**2019 SMP PACKAGE I
(AVENIDA PRIMA, LA AVENTURA, & LA BAHIA)
Solicitation Number: CO-00201
Job No.: 18-5008 and 18-5508**

**ADDENDUM NO. 1
August 14, 2018**

MAP No. 188622 AND 190620 SHEET 22
SECT. No. OF 29
DR. CK. JOB No. 18-5008

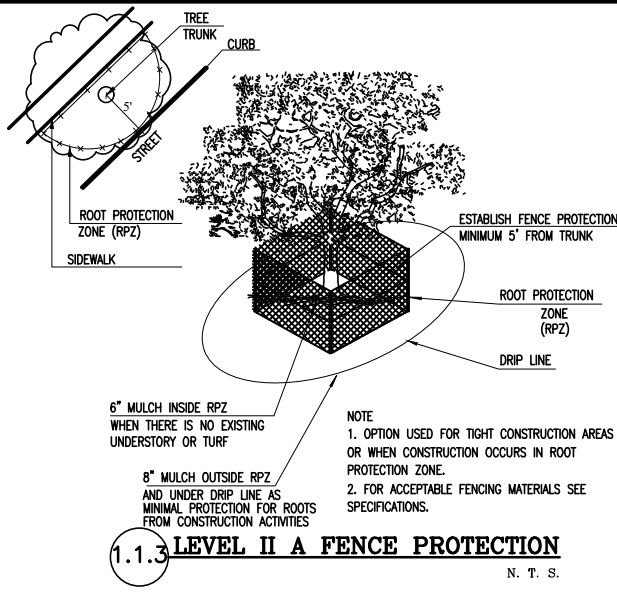
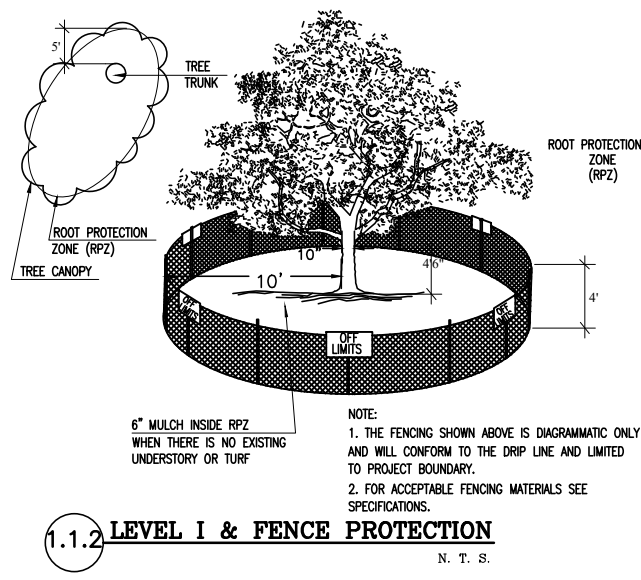
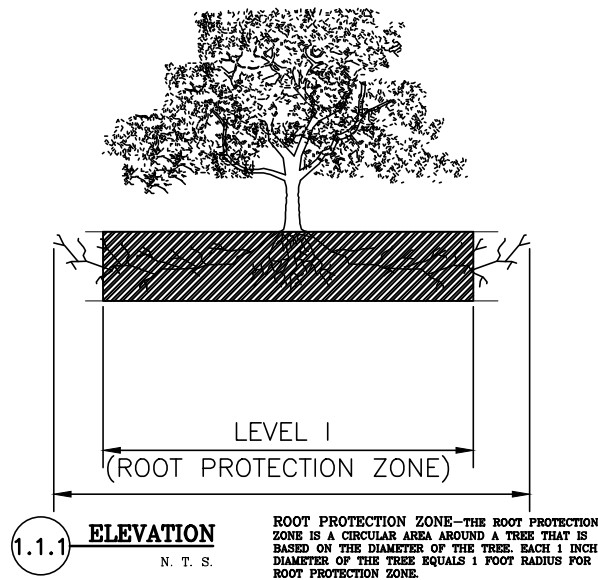
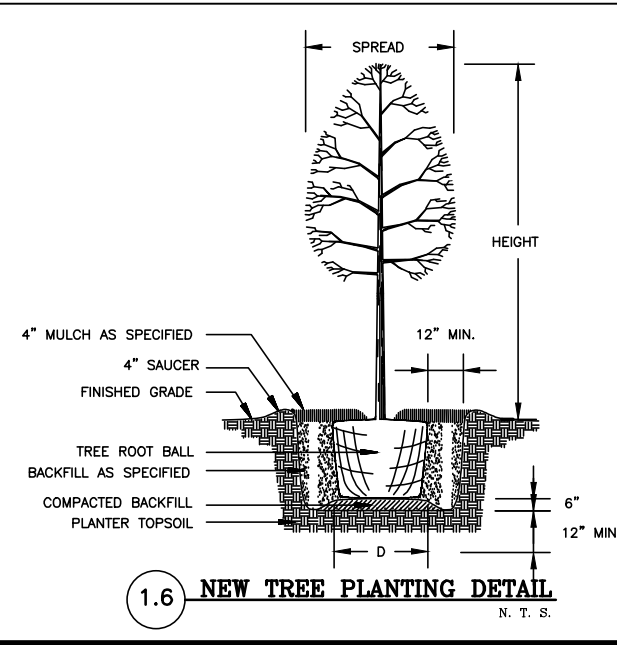
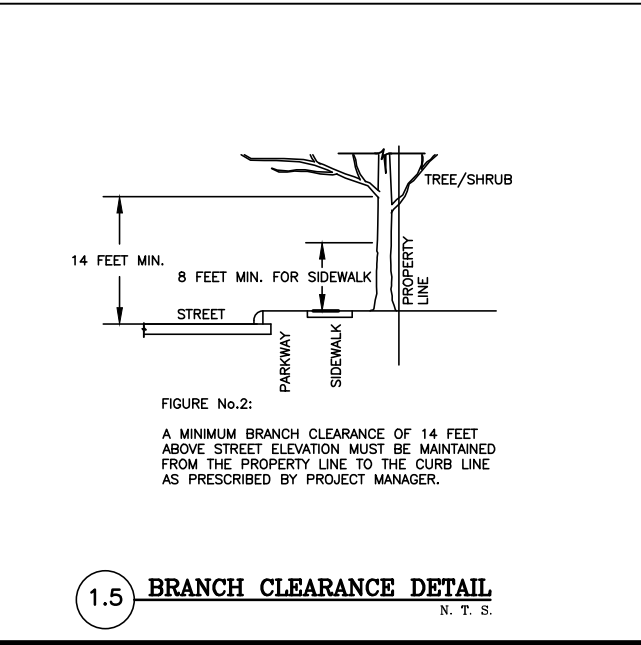
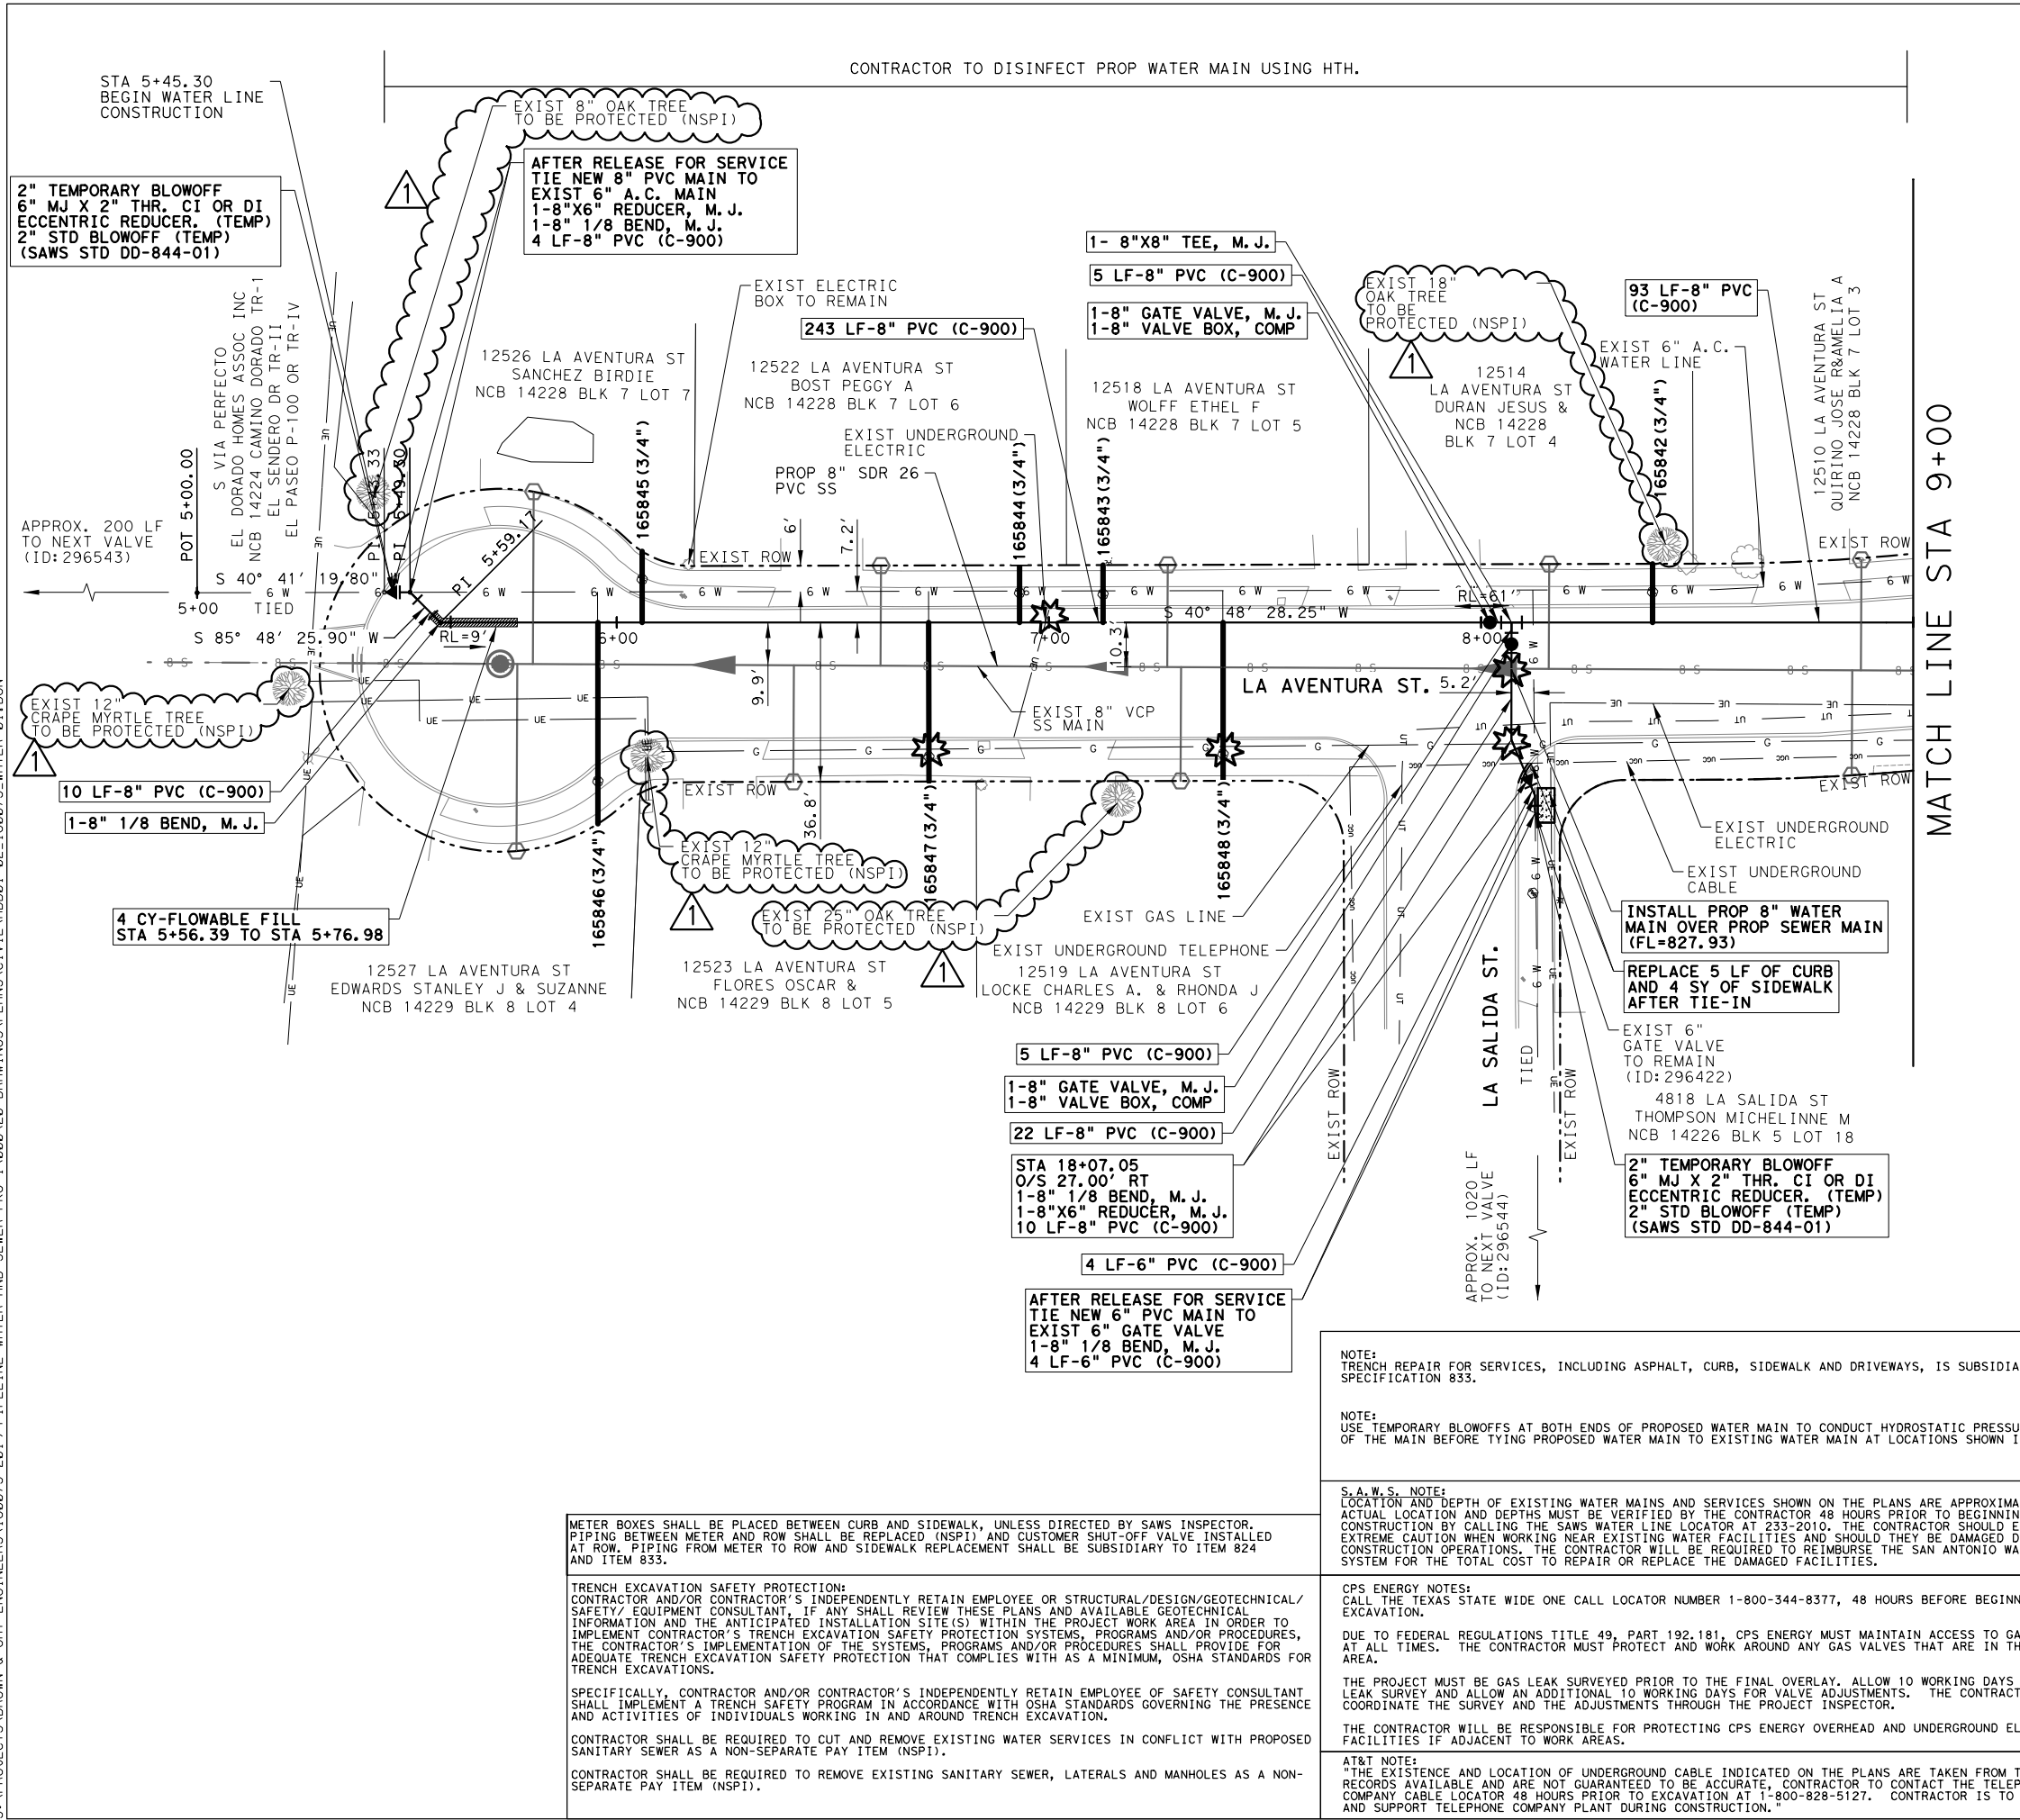
9. DELETE **Sheet 22 of 29** of the WATER PLANS in its entirety and REPLACE with the attached **Sheet 22 of 29**, dated 7/27/18. Sheet 22 has been revised to show updated tree protection table and tree general note 13.
10. DELETE **Sheet 26 of 29** of the WATER PLANS in its entirety and REPLACE with the attached **Sheet 26 of 29**, dated 7/27/18. Sheet 26 has been revised to show updated tree species and/or location.
11. DELETE **Sheet 28 of 29** of the WATER PLANS in its entirety and REPLACE with the attached **Sheet 28 of 29**, dated 7/27/18. Sheet 28 has been revised to show updated tree protection table and tree general note 13.
